Serial Number: IFB-FQ14005/RLJ  
Date of IFB Issue: April 30, 2015  
Date of Bid Opening: June 3, 2015, 2:00 P.M.

Amendment Date: May 26, 2015

AMENDMENT NO. 1  
to  
IFB FQ14005/RLJ, Replace Five Chillers  
Crystal City, Metro Center and Potomac Avenue Metrorail Stations  
DC and VA  
TO WHOM IT MAY CONCERN:

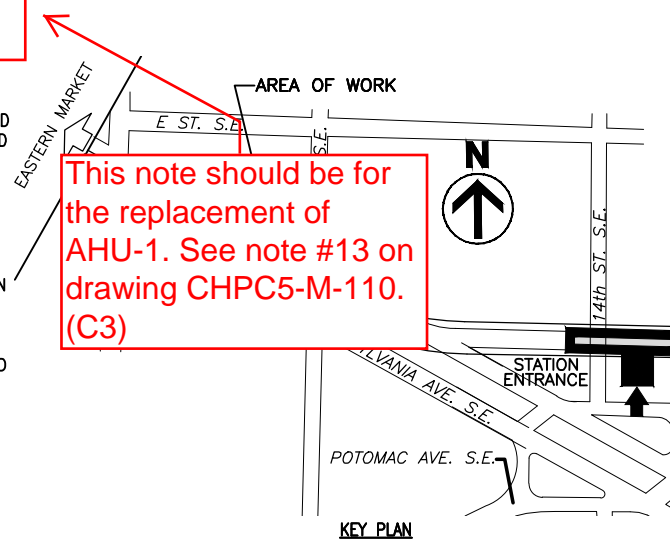
ACU-1 incorrectly labeled; it should be AHU-1. Line weight is also incorrect; it should be heavier to indicate AHU-1 is NEW as indicated on M-602. (C3)

DRAWING NO.  
**M-603**

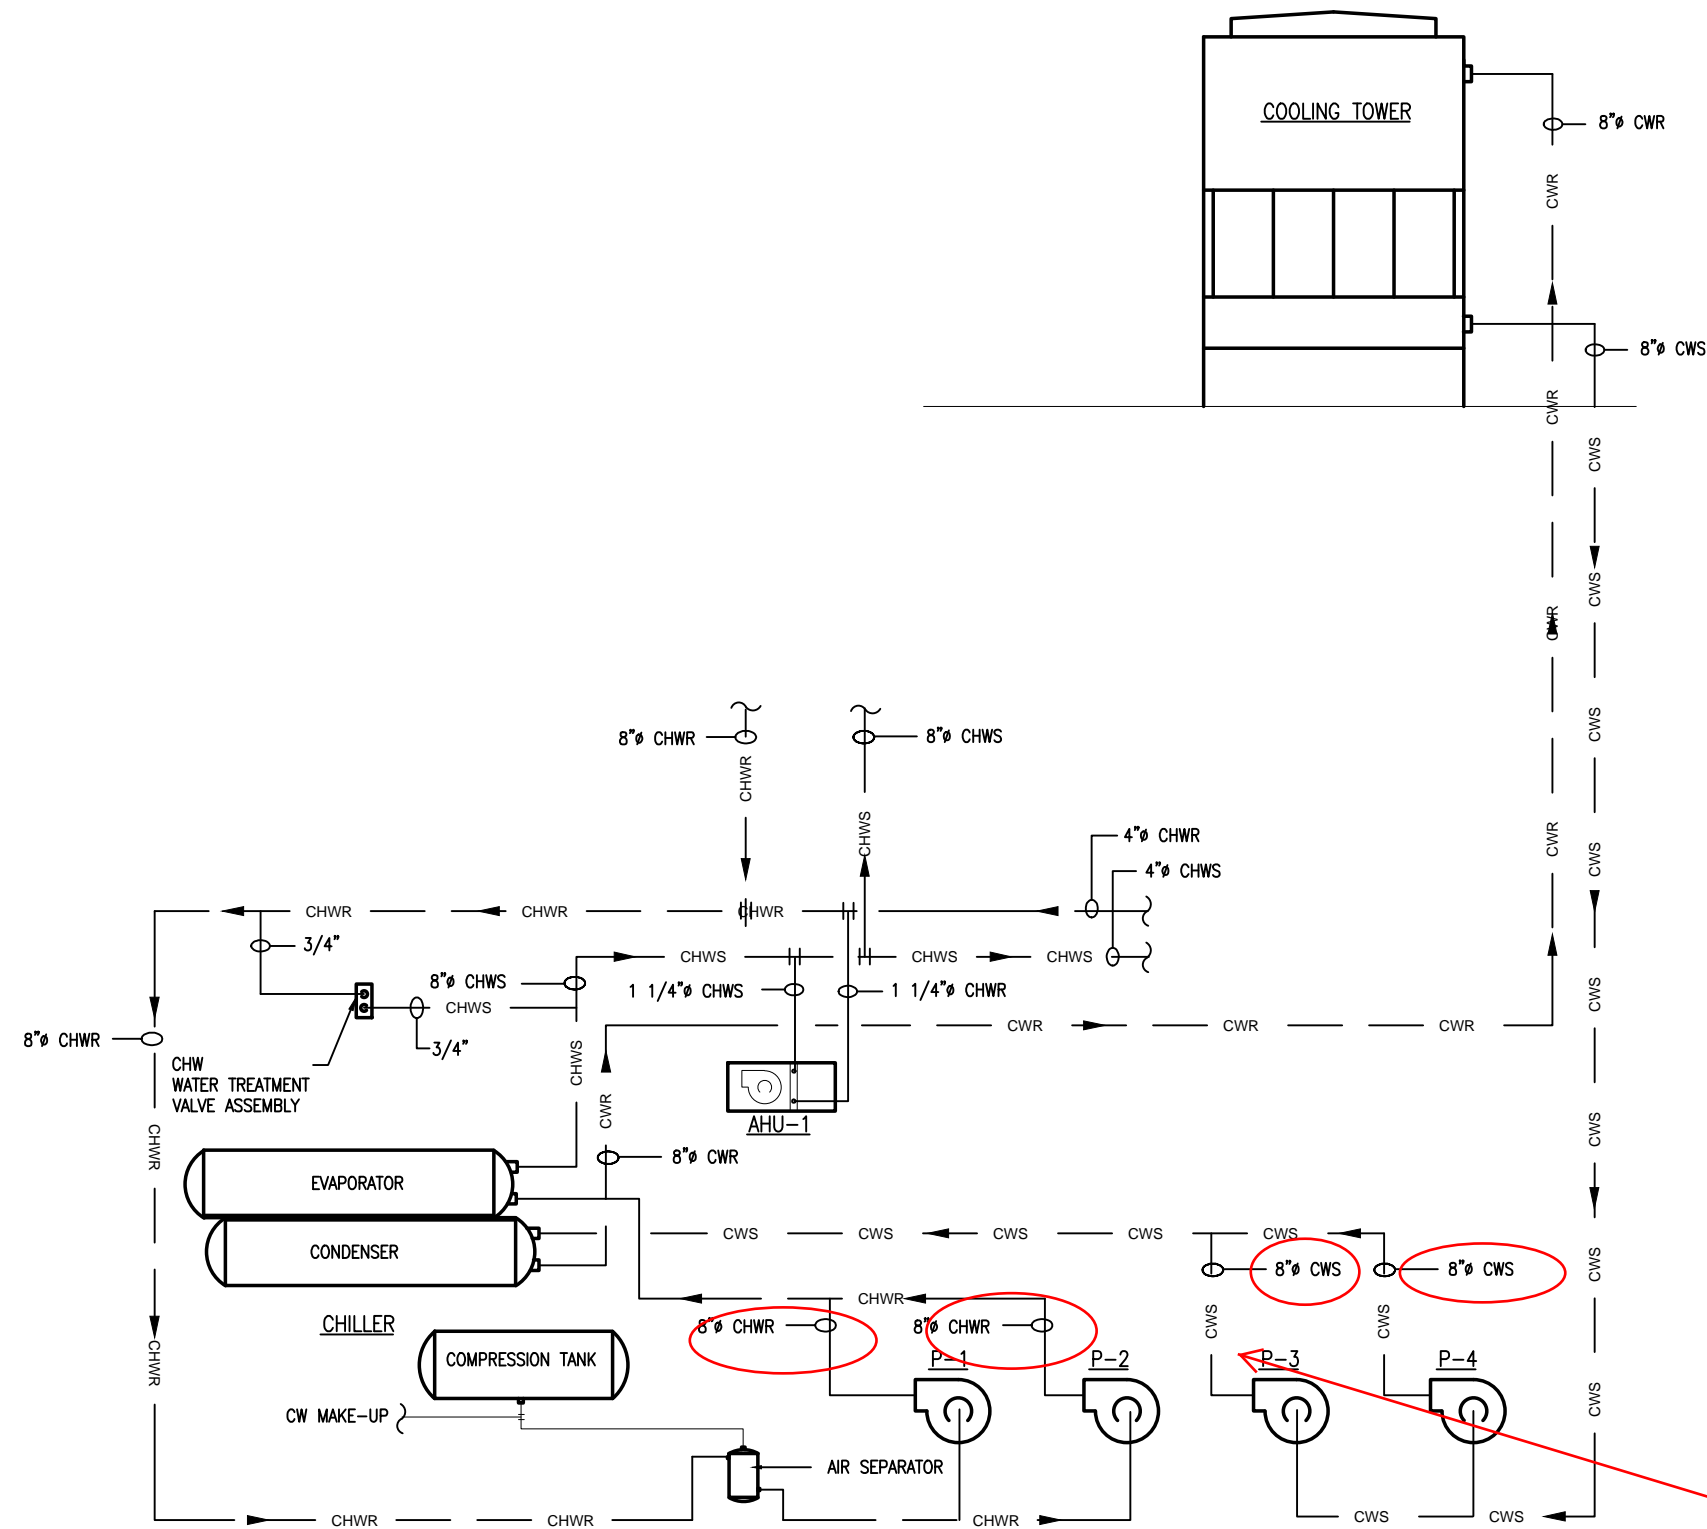
Note all CWS piping is 10" at this location, with the schedule indicating 8" inlet, 6" outlet. This confirms that Crystal City 6" inlet, 5" outlet is correct. (C1)

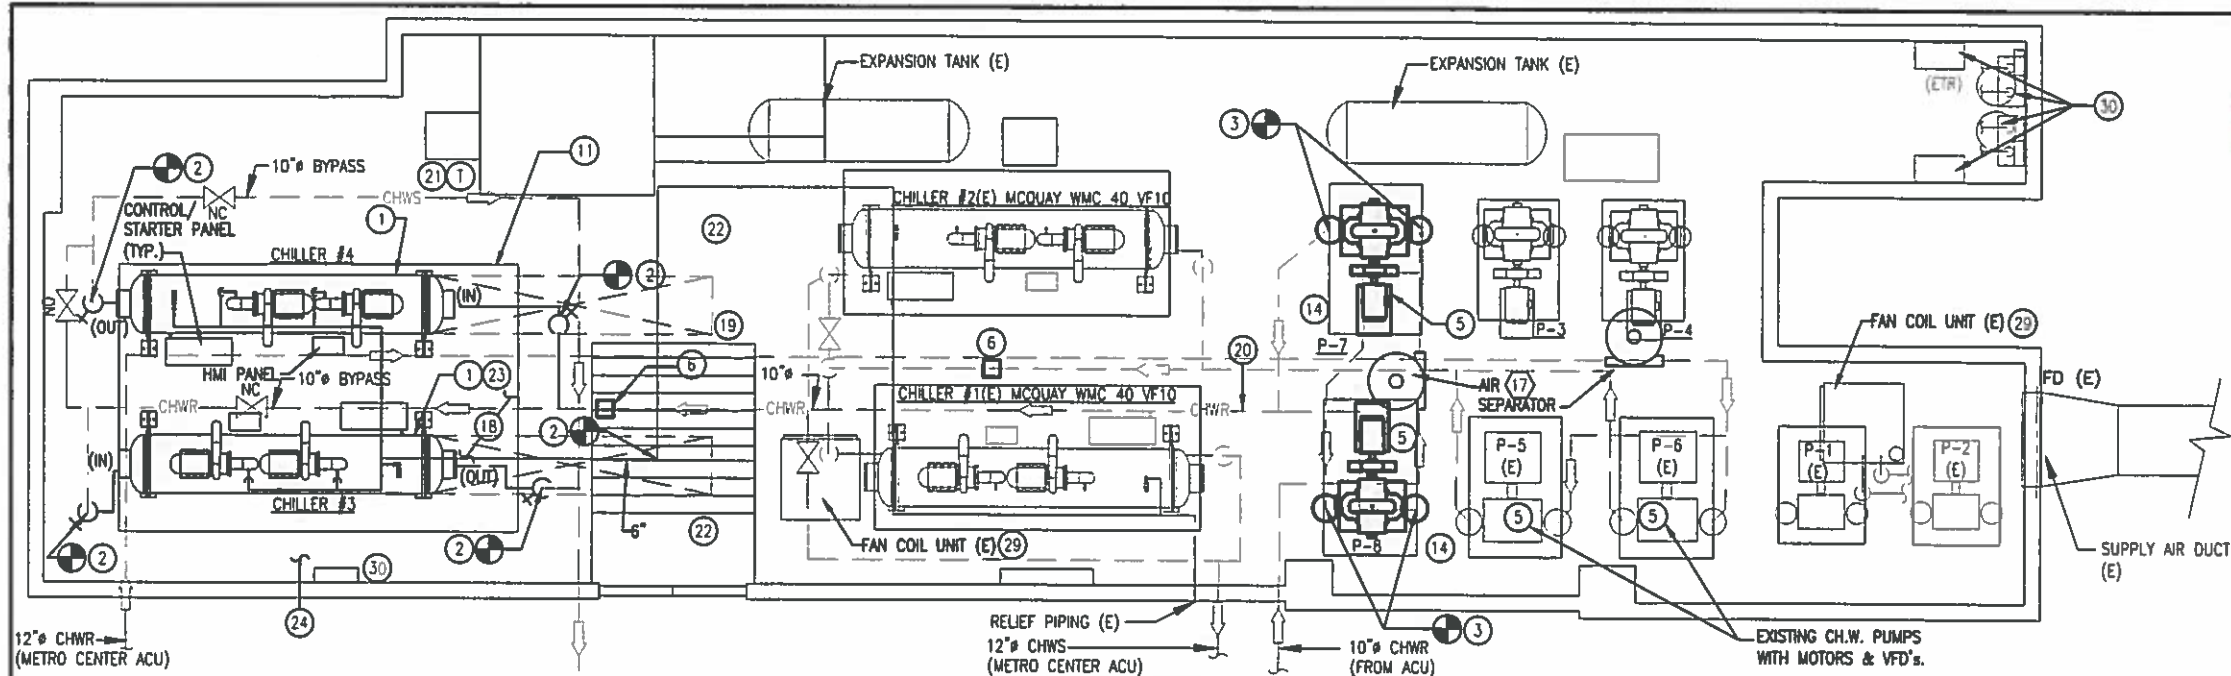
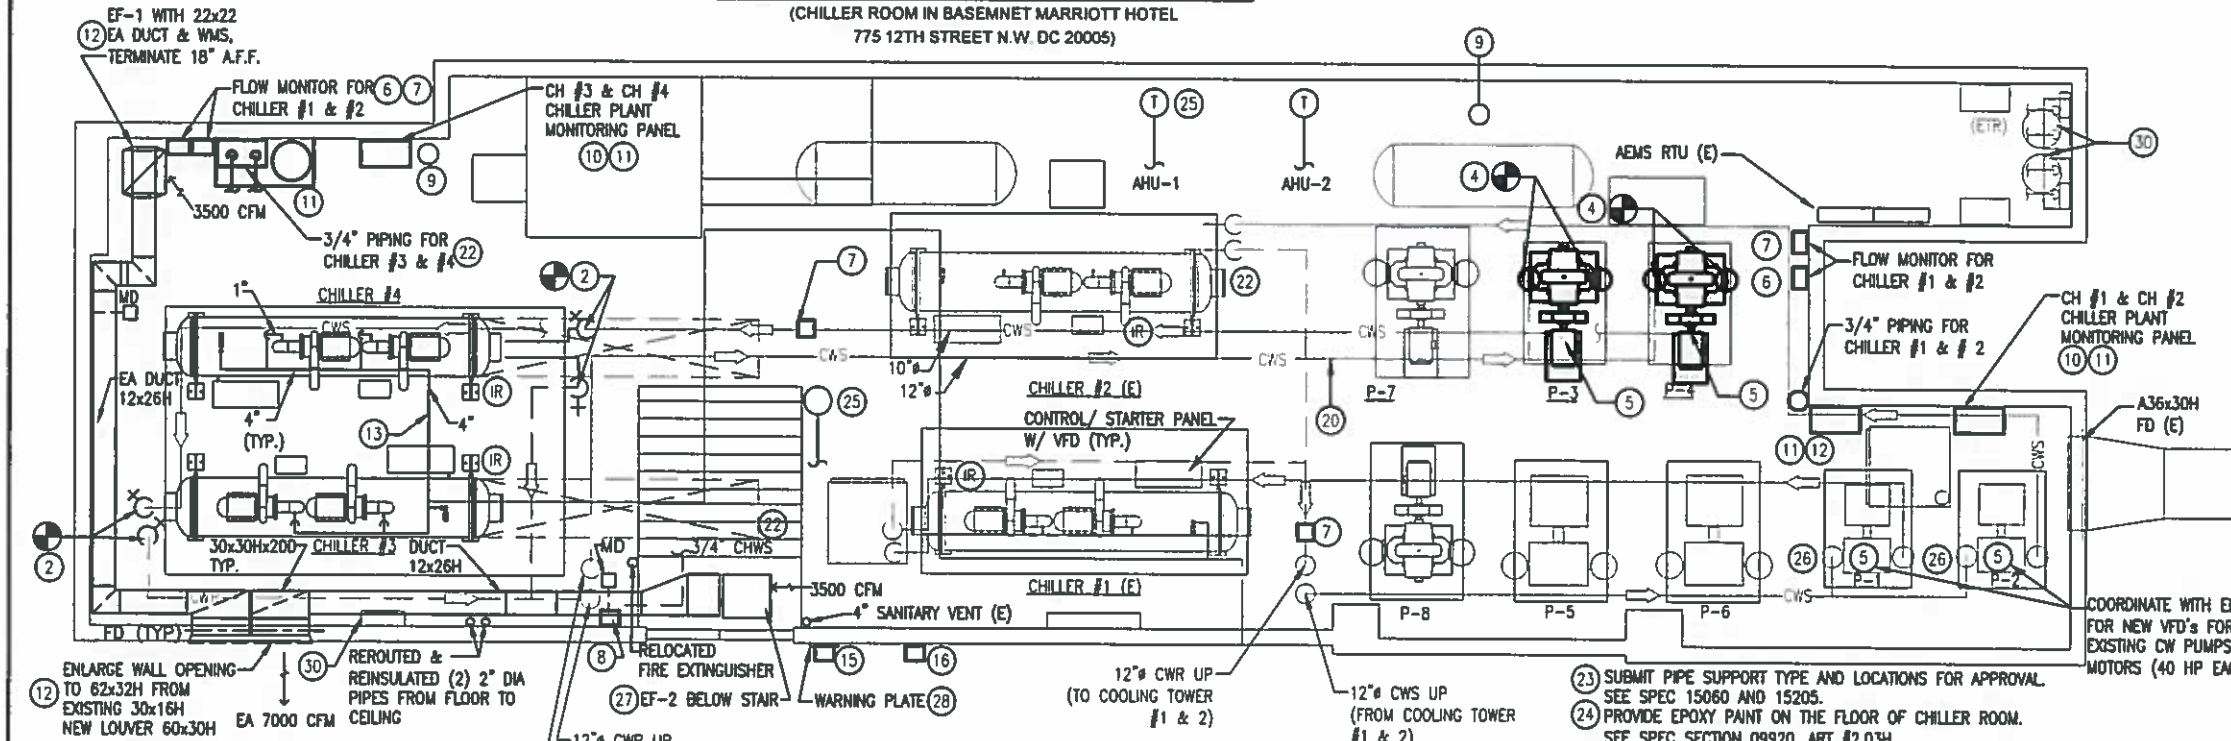
Pumps P-1, P-2, P-3, and P-4 all have 8" piping. (C1)
